Project No. 2021\_154

MIDLOTHIAN ISD STADIUM ADDITIONS AND RENOVATIONS

ADDENDUM NO. 2

DATE: October 18, 2021

PLAN NORTH TRUE NORTH  
1 FLOOR PLAN - UPPER LEVEL - PRESS BOX - POWER  
SCALE: 1/8" = 1'-0"

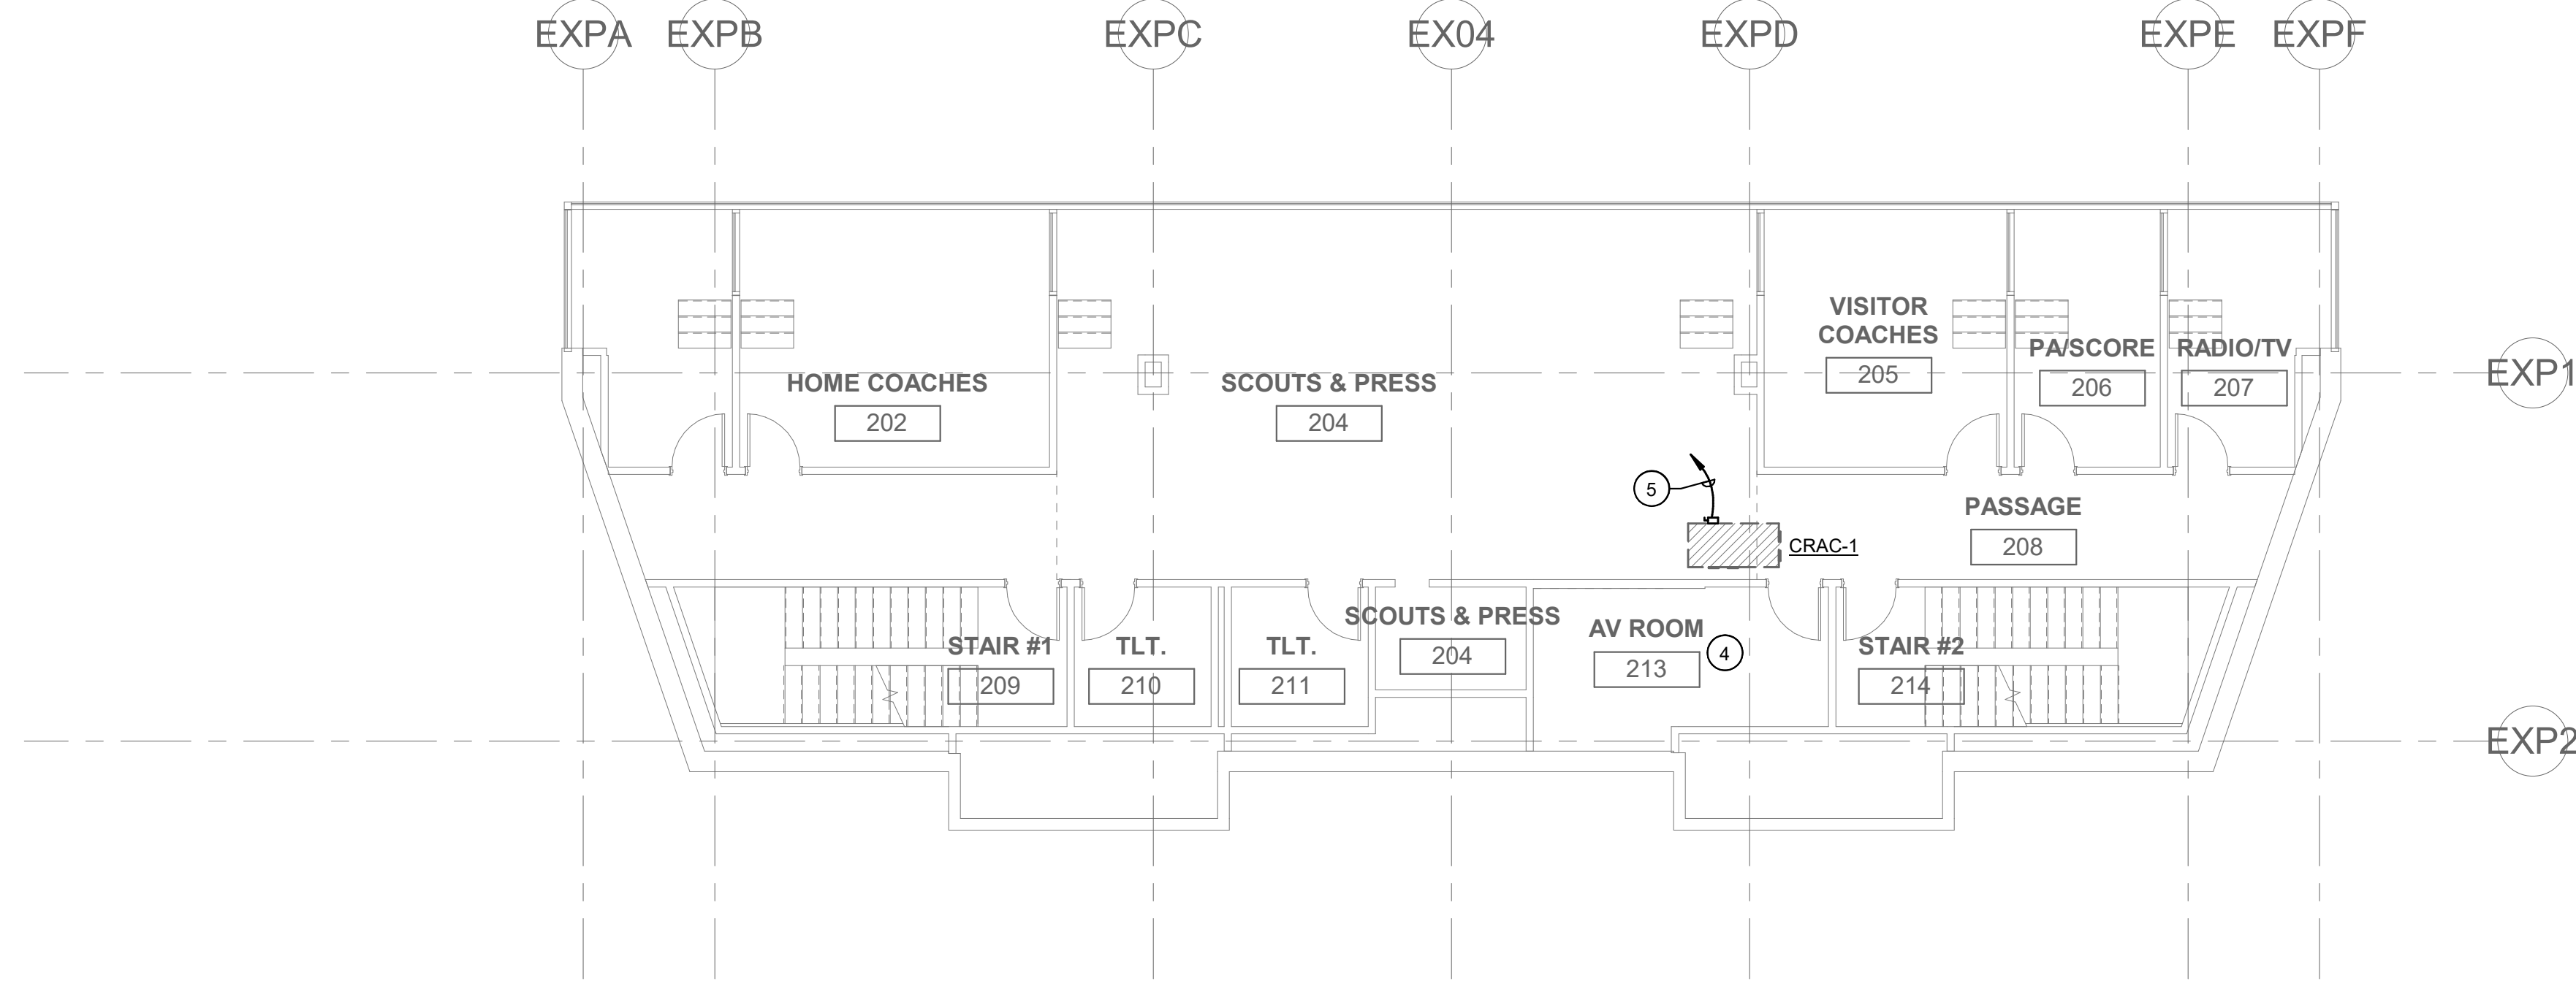
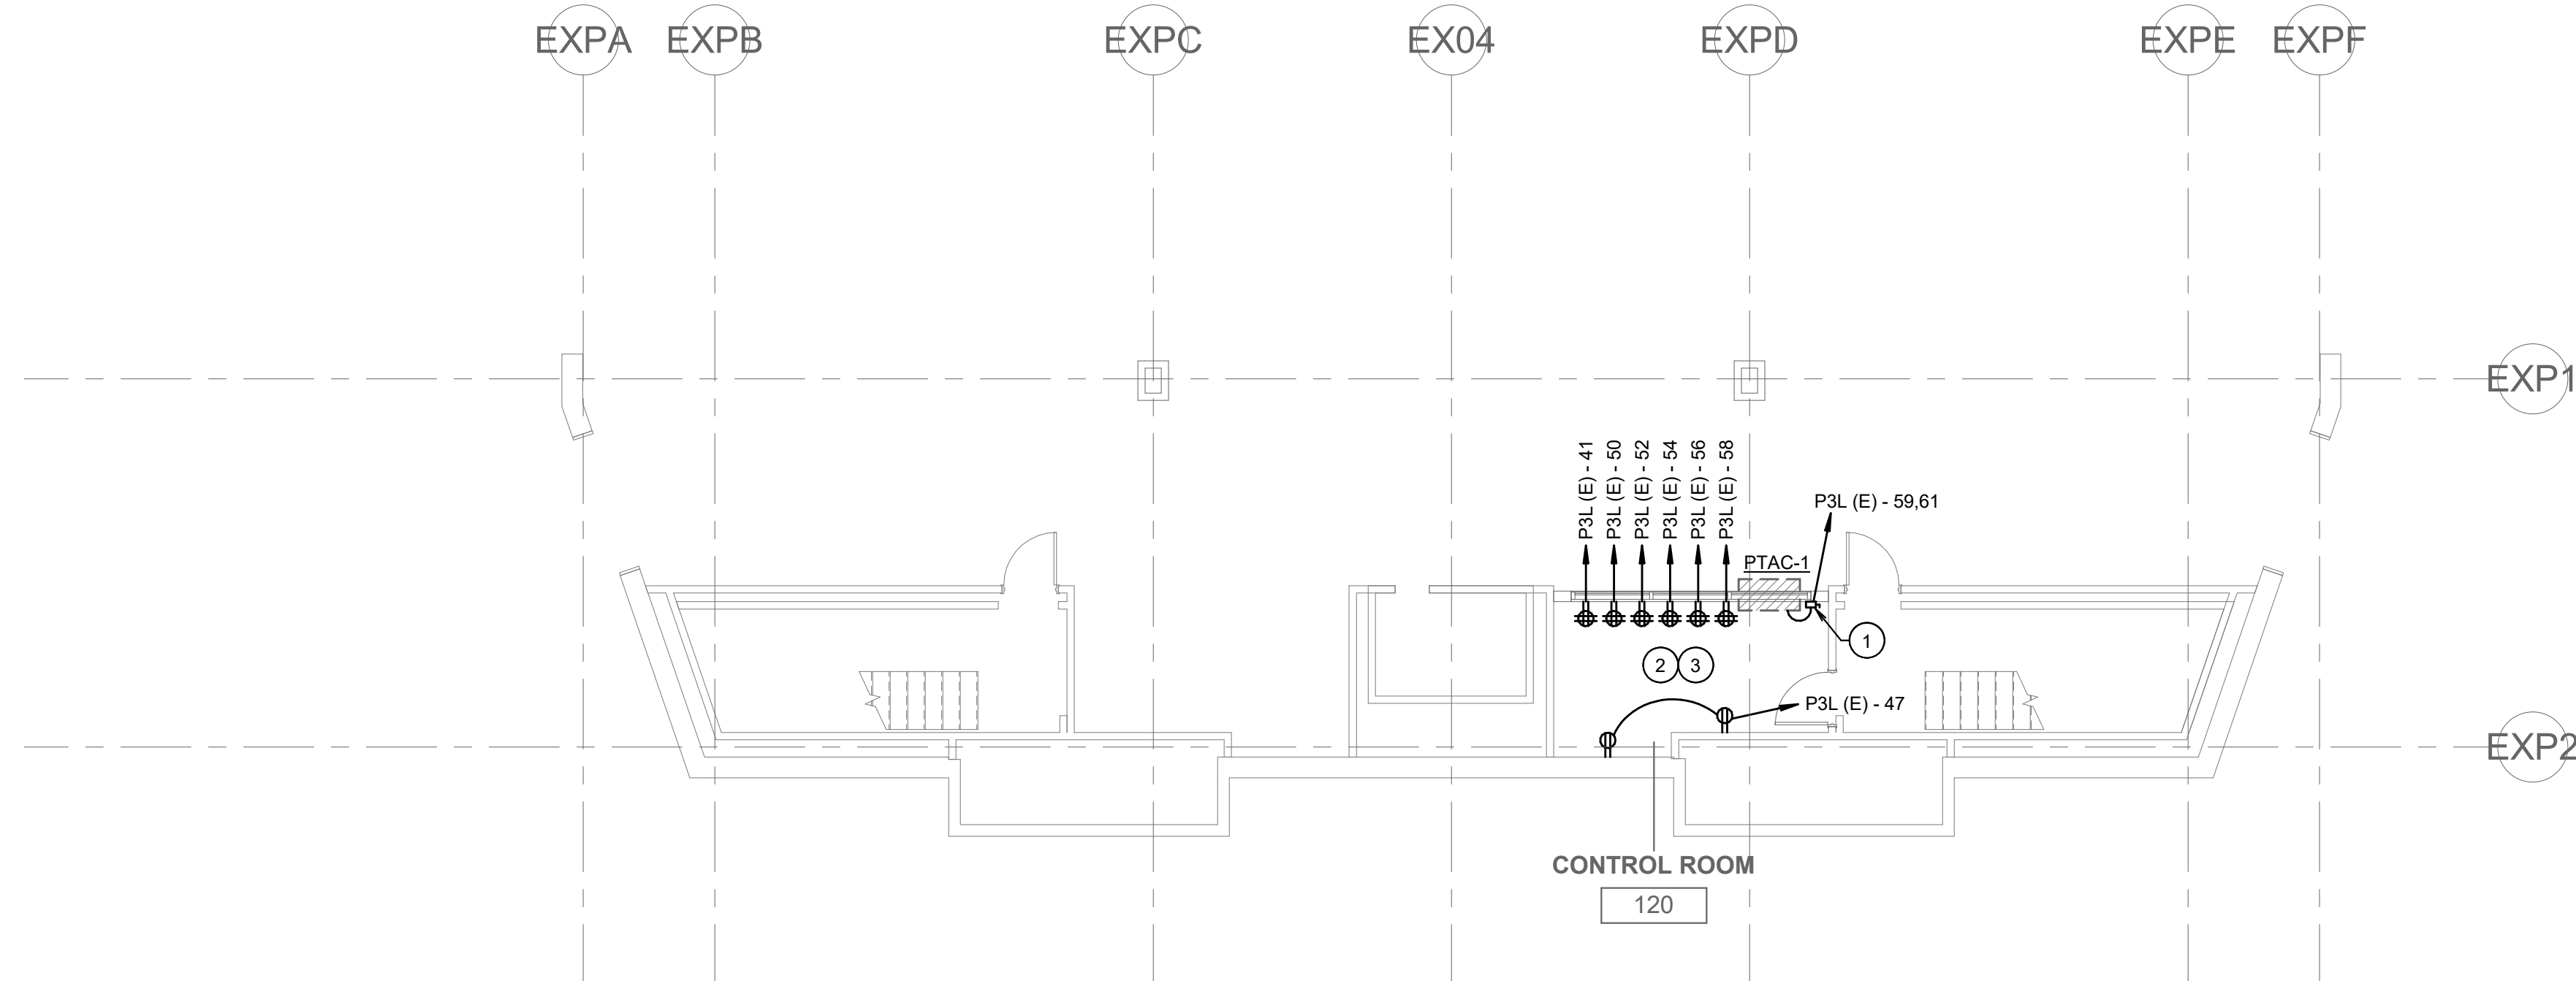
- A2.38 SHEET E-103 – FLOOR PLAN – PRESS BOX – POWER:  
ADD in its entirety.  
a. Refer to attached NEW drawing for ADDED/MODIFIED power to the porch level and lower level of the Press Box.
